Docket Item # 11
BAR CASE # 2009-0149

BAR Meeting
July 29, 2009

ISSUE: Alterations

LOCATION: 424 N. Washington Street

Figure 2: Proposed Rear Façade

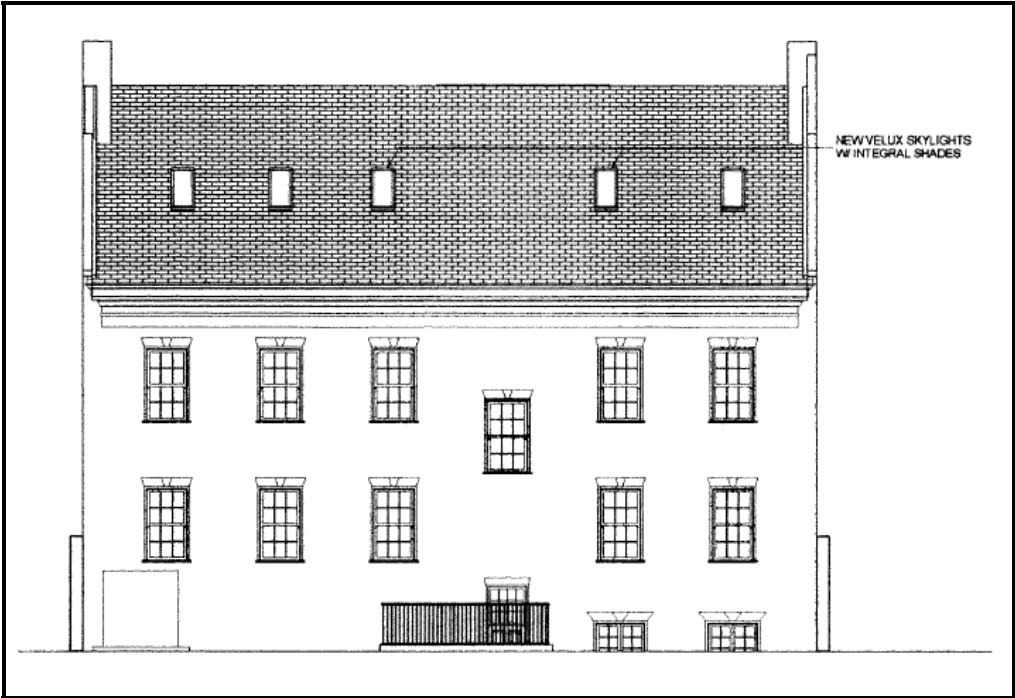
In the opinion of Staff, the proposed new skylights are appropriate. They are relatively modest in size, have a low profile and will contain a cellular shade – all specifications recommended in the *Guidelines*. Finally, the skylights will be located on the rear roof slope of the building – the least visually prominent section of the roof, and will only be visible from Oronoco Street, thus retaining the integrity of Washington Street corridor.
